**Rio Hondo Community College District
Contract Management and Vending Services
3600 Workman Mill Road, A-103
Whittier, CA 90601-1699**

**February 14, 2023
Addendum No. 4
Bid No. 2090: Re-Roofing of Science Building Project**

RHC SCIENCE BUILDING NEW ROOF
ANSWERS TO PRE-BID CLARIFICATION REQUESTS

RHC - SCIENCE BUILDING NEW ROOF

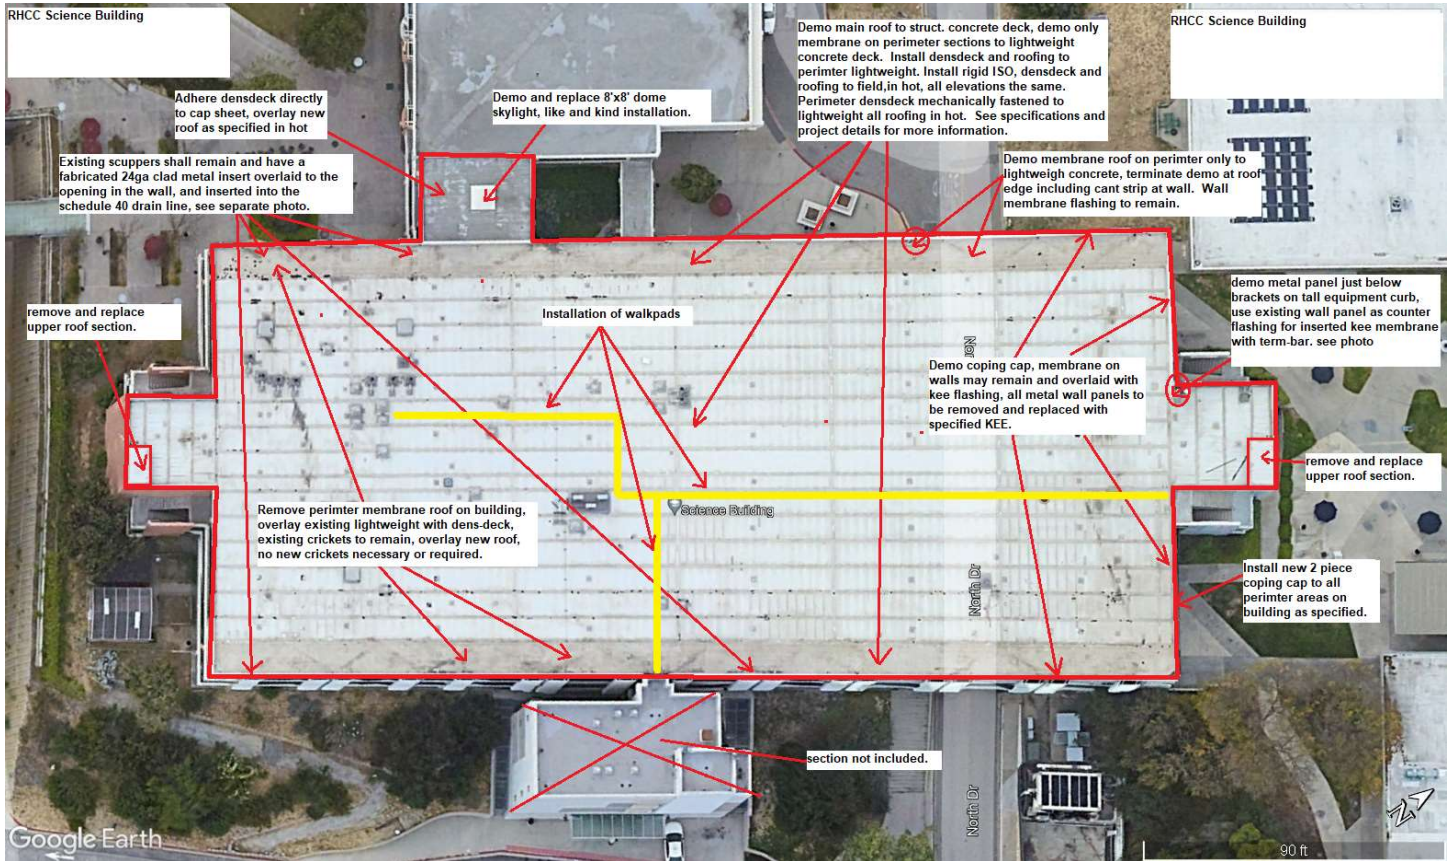
12. RFC 2 – Q. Will we reuse the existing scuppers or replace with new? What material and gauge will they be if new?

A. Existing scuppers shall be overlaid with fabricated 24 ga pvc clad metal as specified and called out in the addendum. Scuppers shall remain and be encapsulated with new fabricated 24 ga pvc clad metal. Clad piece shall be flashed onto walls and inserted into schedule 40 pipe on exit. Owner will remove the existing electrical conduit and relocate to field.

Owner to relocate electrical conduit to field of roof from existing wall location.

Encapsulate scupper to wall and field with KEE/Clad, line schedule 40 drain with fabricated clad metal.

Section to be demoed at red line.

SCUPPER (THROUGH WALL)

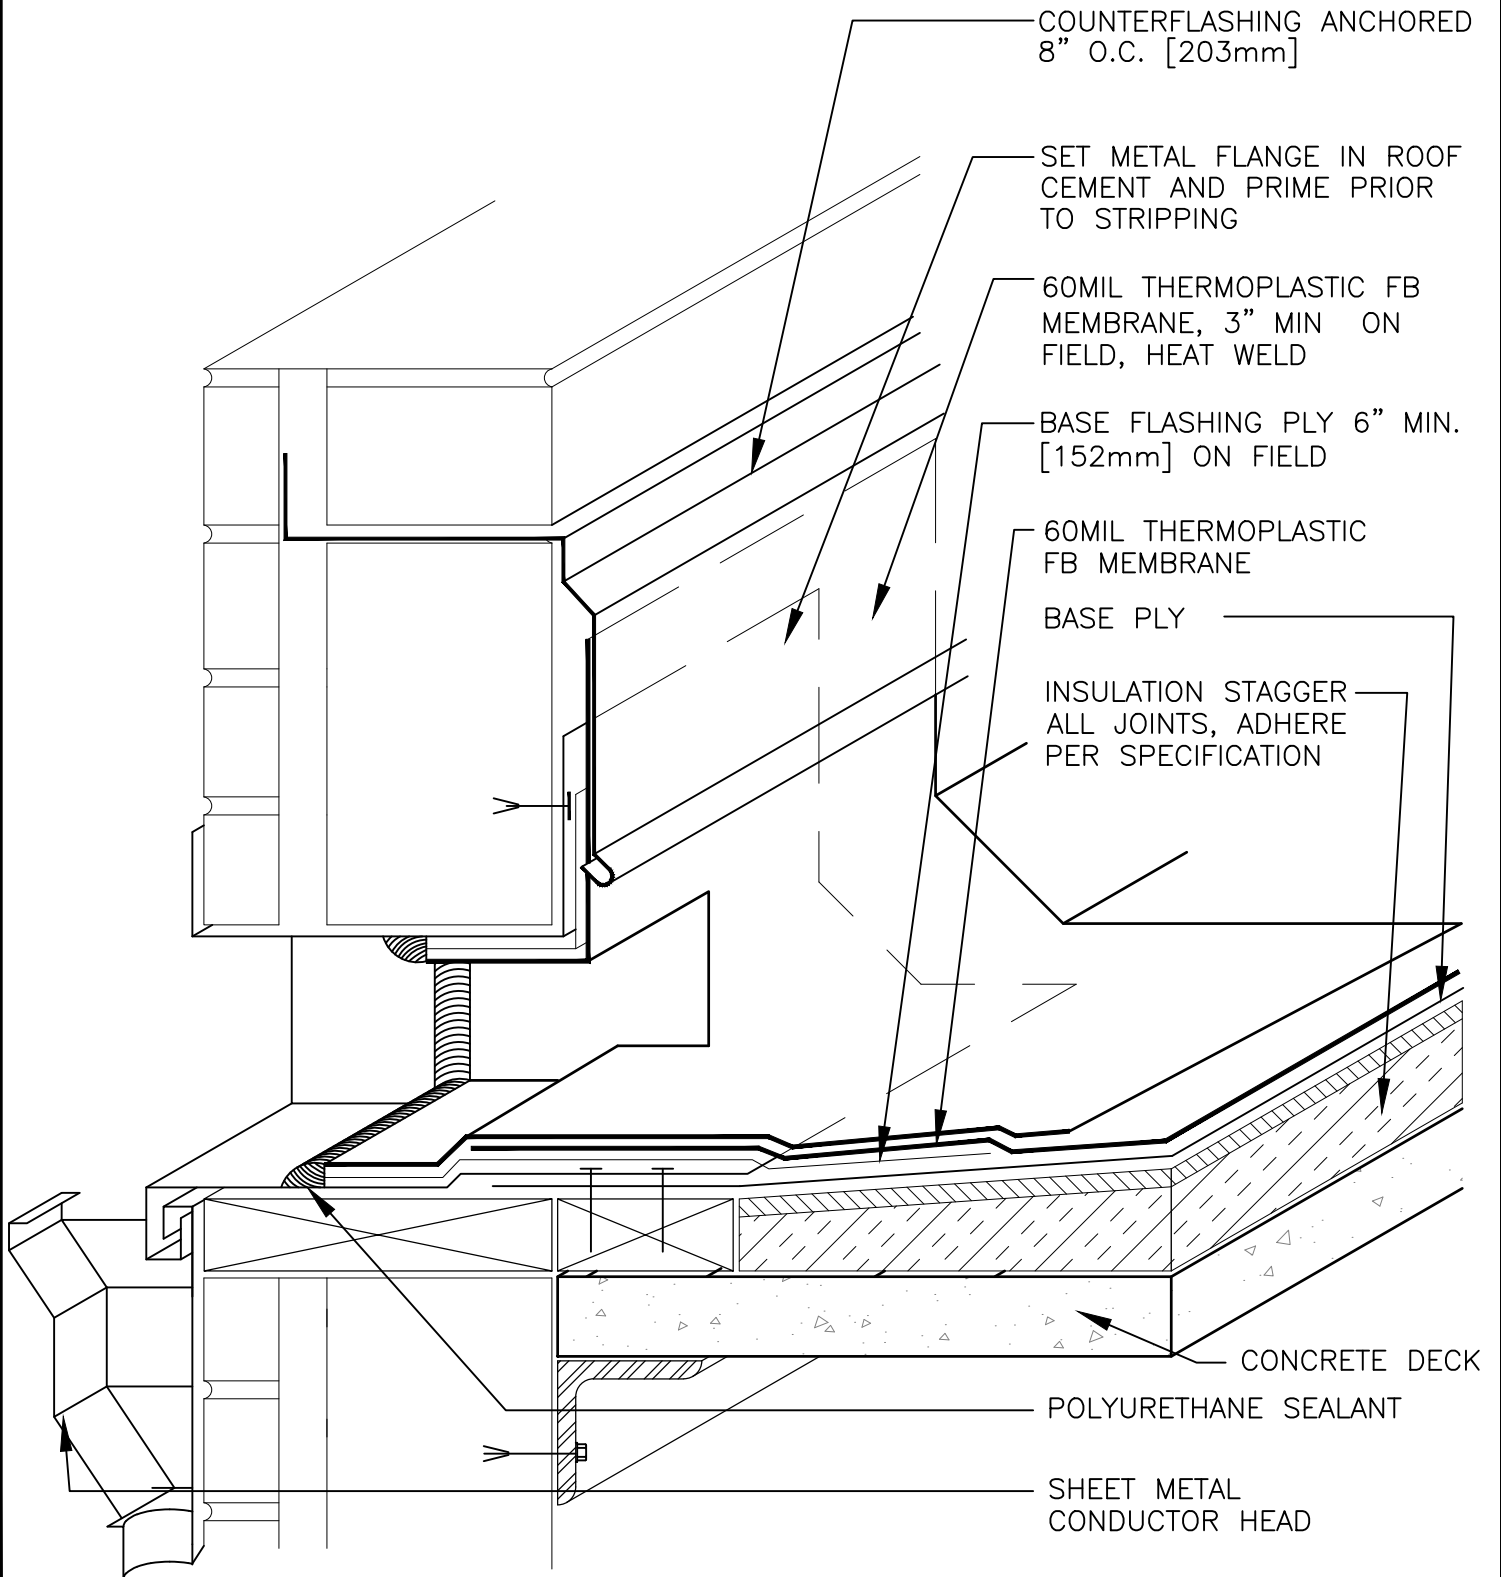
Remove existing roofing to expose scupper.

ALL PLIES SET IN BITUMEN SEE
SPECIFICATIONS FOR SURFACING
